### APPEAL SUMMARY

<b>Appeal ID:</b> 16055	<b>Project Address:</b> 6715 NE 24th Ave
<b>Hearing Date:</b> 11/1/17	<b>Appellant Name:</b> Ed Spencer
<b>Case No.:</b> B-003	<b>Appellant Phone:</b> 503-460-9313
<b>Appeal Type:</b> Building	<b>Plans Examiner/Inspector:</b> Maureen McCafferty
<b>Project Type:</b> residential	<b>Stories:</b> 2 <b>Occupancy:</b> R-1 <b>Construction Type:</b> V-B
<b>Building/Business Name:</b>	<b>Fire Sprinklers:</b> No
<b>Appeal Involves:</b> Alteration of an existing structure	<b>LUR or Permit Application No.:</b> 17-199860-RS
<b>Plan Submitted Option:</b> pdf [File 1]	<b>Proposed use:</b> SFR

### BUILDING CODE APPEAL 17-199860-RS

(E) BLDG. SECTION A/1  
SCALE: 1/4" = 1'-0"

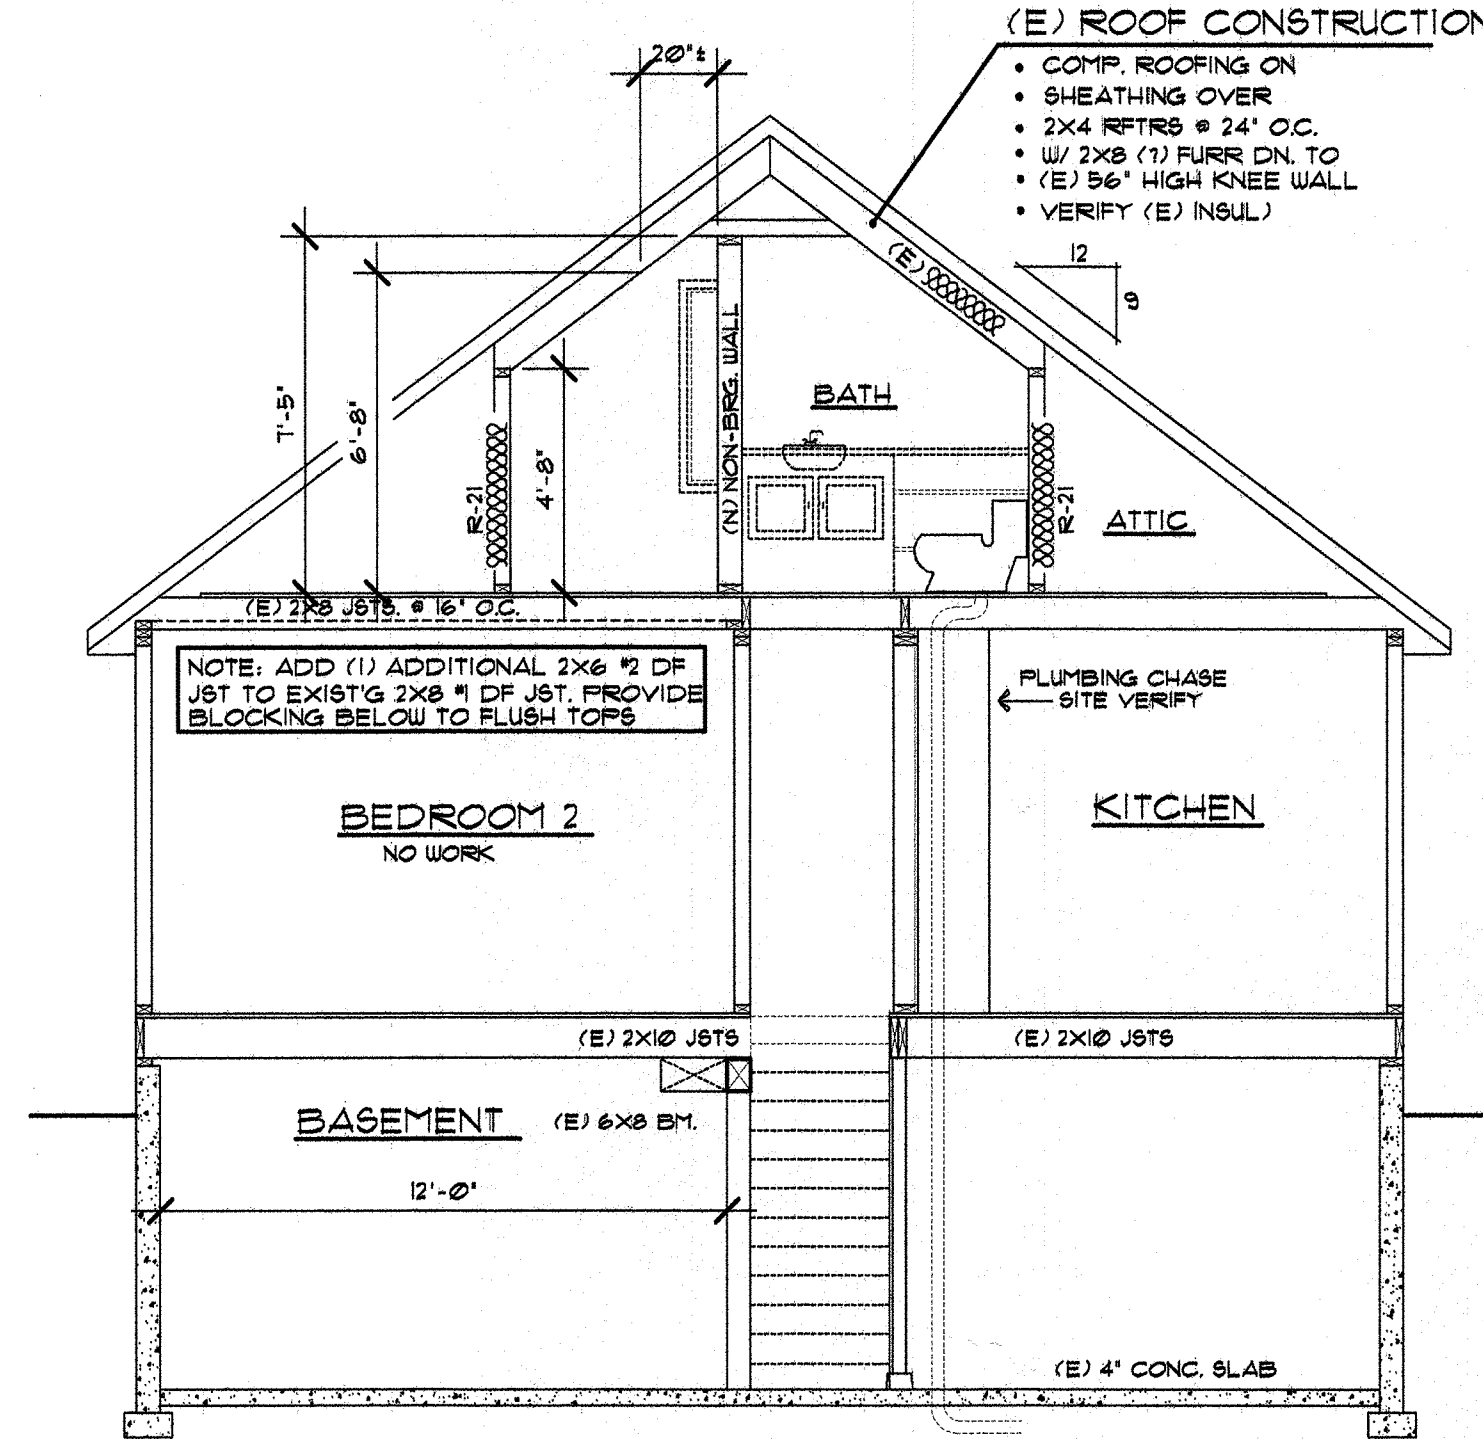
**Proposed Design** In applying for a Dormer permit the homeowner, Liz Idlewine, eventually realized that before she purchased the home a previous owner had converted the existing attic into living space. Liz insisted on including "legalizing" the converted attic within this permit. When the original unpermitted work was done it appears that the ceiling was furred down to provide additional space for insulation resulting in a slightly lower ceiling height along the stair railing. In the new design the passage distance with the lower ceiling was increased in length by 4'-8" to accommodate a bathroom. Currently, and as with the new design, there is 15" width of minimum 7'-0" ceiling height and 20" width of 6'-8" ceiling height. The lowest ceiling height width at 36" is 5'-8". With the addition of the Dormer the minimum 70 square feet of 6'-8" ceiling height has been greatly increased to 67½6 of floor area. With regard to the additional 4'-8" length of reduced hallway ceiling height the homeowner would argue that she has been using the area with no limitations and also that the addition of insulation material in the furred down area is of greater importance to her.

**Reason for alternative** The only way to absolutely rectify this issue would be to remove the additional framing material and insulation which perhaps would not even then provide full relief but would certainly reduce the Thermal Performance of the area. Therefore, we request that the existing conditions, as shown in the attached plan, be allowed to remain and be approved as shown.

Section R305 of the 2014 Oregon Residential Specialty Code required a ceiling height of 7 feet for, among other areas, Hallways, (Brochure #9 "Converting Attics and Basements...." Allow for 6'-8"). In applying for a Dormer permit the homeowner, Liz Idlewine, eventually realized that before she purchased the home a previous owner had converted the existing attic into living space. Liz insisted on including "legalizing" the converted attic within this permit. When the original unpermitted work was done it appears that the ceiling was furred down to provide additional space for insulation resulting in a slightly lower ceiling height along the stair railing. In the new design the passage distance with the lower ceiling was increased in length by 4'-8" to accommodate a bathroom. Currently, and as with the new design, there is 15" width of minimum 7'-0" ceiling height and 20" width of 6'-8" ceiling height. The lowest ceiling height width at 36" is 5'-8". With the addition of the Dormer the minimum 70 square feet of 6'-8" ceiling height has been greatly increased to 67% of floor area. With regard to the additional 4'-8" length of reduced hallway ceiling height the homeowner would argue that she has been using the area with no limitations and also that the addition of insulation material in the furred down area is of greater importance to her. The only way to absolutely rectify this issue would be to remove the additional framing material and insulation which perhaps would not even then provide full relief but would certainly reduce the Thermal Performance of the area. Therefore, we request that the existing conditions, as shown, be allowed to remain and be approved as shown.

**Reduction in 2nd floor ceiling height: Granted provided all conditions of Brochure #9 are met.**
